AREVA NP RESPONSE to FOURTH REQUEST FOR ADDITIONAL INFORMATION (RAI)

ANP-10272, "SOFTWARE PROGRAM MANUAL FOR TELEPERM XS™ SAFETY SYSTEMS
TOPICAL REPORT" (TAC NO. MD3971) PROJECT NUMBER 733

Figure 71-1 – Test Document Work Flow and Control Points

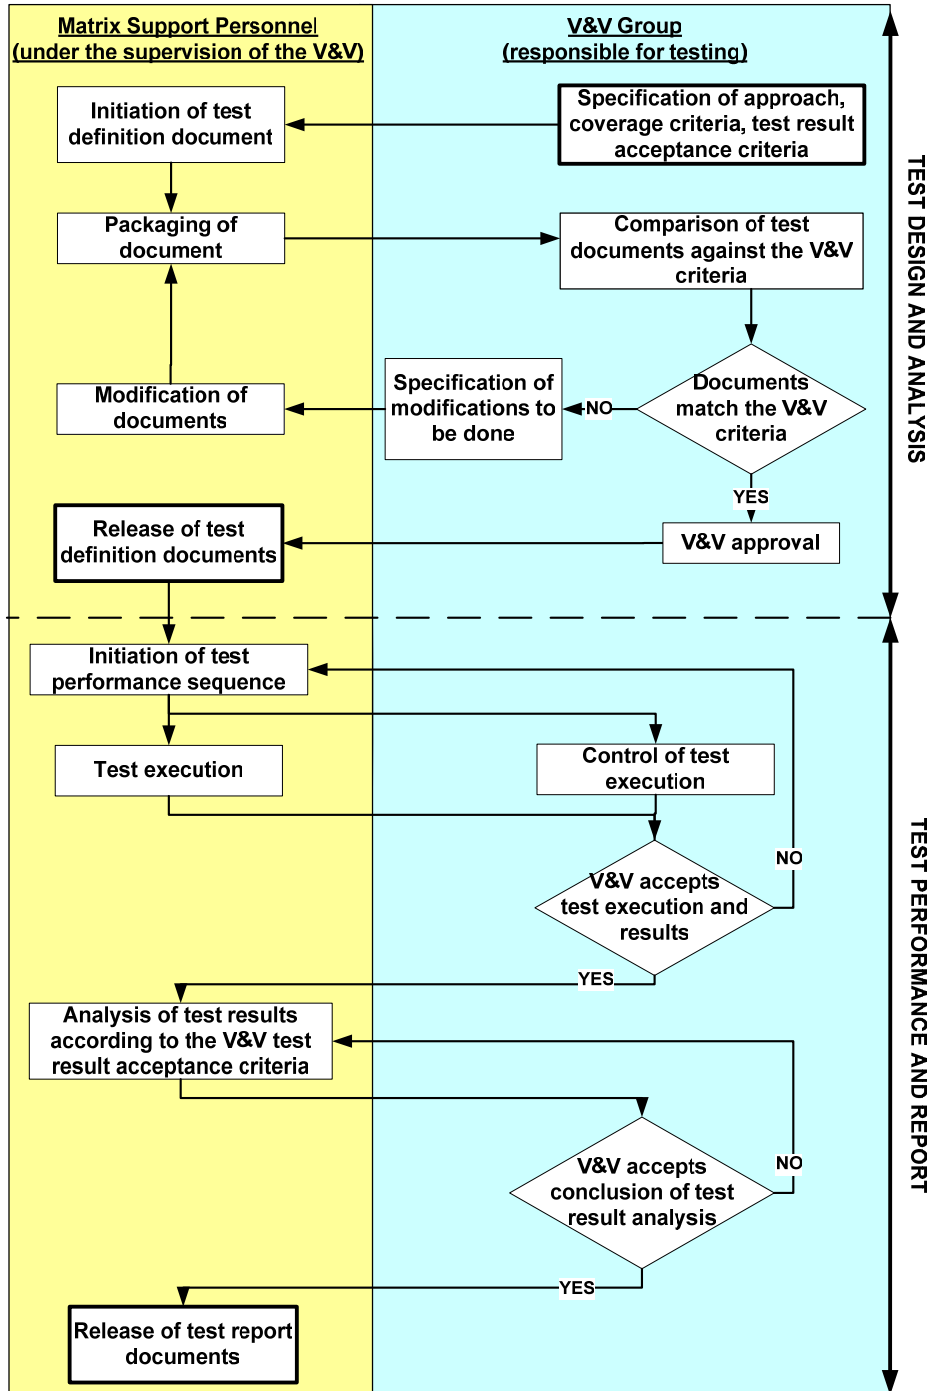
RAI-71 Question: What is AREVA NP's justification for deviating from IEEE 1012-1998 in allowing the software design organization to design and run verification and validation (V&V) tests in place of the V&V organization?

Allowing the software design organization to design and run V&V tests in place of the V&V organization indicates a loss of that diverse defensive layer in a safety-critical stage of software testing. Various errors of interpretation and implementation which may have been introduced into the software by the thinking of the software design organization will likely be masked in the design and execution of the V&V tests through those same pathways of interpretation if executed by the same organization. AREVA NP has not explained or justified how its procedures and methods will mitigate these possible errors in lieu of fully complying with IEEE 1012 (by maintaining the V&V organization's complete responsibility for the design and execution of V&V tests). It has also not detailed any specific requirements of the V&V organization in this scenario.

The staff requires additional information to determine if the proposed alternative to the requirements of IEEE 1012 will provide an equivalent confidence in a high quality test process, and therefore an equivalent confidence in the safety of the resultant system.

AREVA NP has agreed to modify its approach to validation testing.

The Software Verification and Validation Plan (SVVP) conforms to the guidance of the applicable recommendations of IEEE Std 1012-1998, as endorsed by Regulatory Guide 1.168, Revision 1. One area of exception with regard to the IEEE Std 1012-1998 is the use of matrixed support personnel from the development groups to perform some of the validation test activities. The Verification and Validation (V&V) group may get assistance from the Software Design group, Hardware Design group, and the Test group for the preparation of validation test specifications, procedures, and reports and the performance of test tasks; however, these support personnel shall work under the supervision of the V&V group. These support personnel may not develop software test documents for design work they prepared. These matrixed personnel bring special skills to supplement the validation activities. This testing method ensures that the proper hardware and software personnel are used in an integrated fashion to develop and conduct the system tests, including the Factory Acceptance Test (FAT). The test document workflow and control points are shown in Figure 71-1 to ensure that the independence of validation testing is maintained.

Figure 2.2 from TXS Topical Report

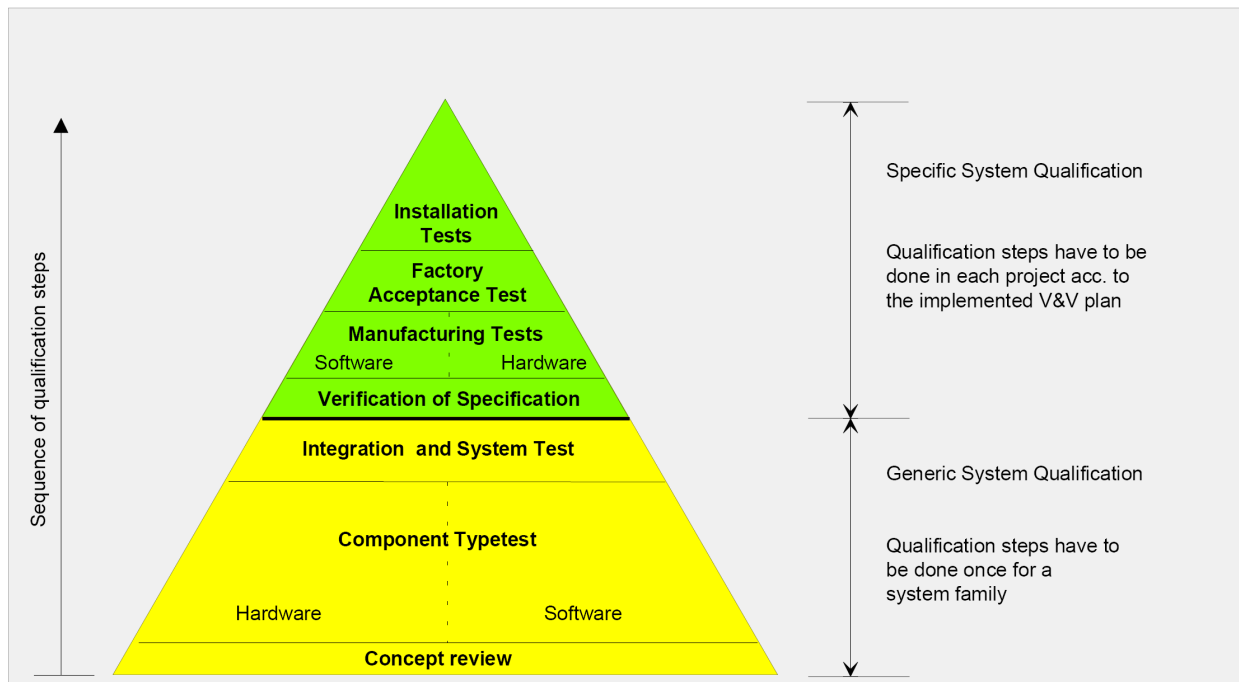
RAI-73 Question: What is AREVA NP's justification for crediting SIVAT testing in reducing the scope of the factory acceptance test (FAT) and other unit and integration testing?

In general, there is no way for the NRC to understand what is meant by a reduction in FAT testing with the information currently provided by AREVA NP. It appears that SIVAT simulates the software's operation. With the use of SIVAT, AREVA NP needs to demonstrate how FAT will fully verify and validate software/hardware integration aspects. AREVA NP should provide procedures and processes that will ensure software/hardware integration aspects are appropriately addressed in the proposed V&V scheme.

The overall qualification process for the TXS system is shown in Figure 2.2 from the TXS Topical Report. The qualification process is a two-part process: generic system qualification and specific system qualification. The qualification process for application software starts with the application-independent (generic) qualification process described in Section 2.1. The generic qualification process included an integration and system test phase. The specific system used for this generic qualification step is described in detail in Section 3.2.2 of the TXS Topical Report.

The overall application independent qualification process is described in Section 2.2 of the TXS Topical Report. The TXS platform qualification process is shown below (reproduction of TXS Topical Report Figure 2.2).
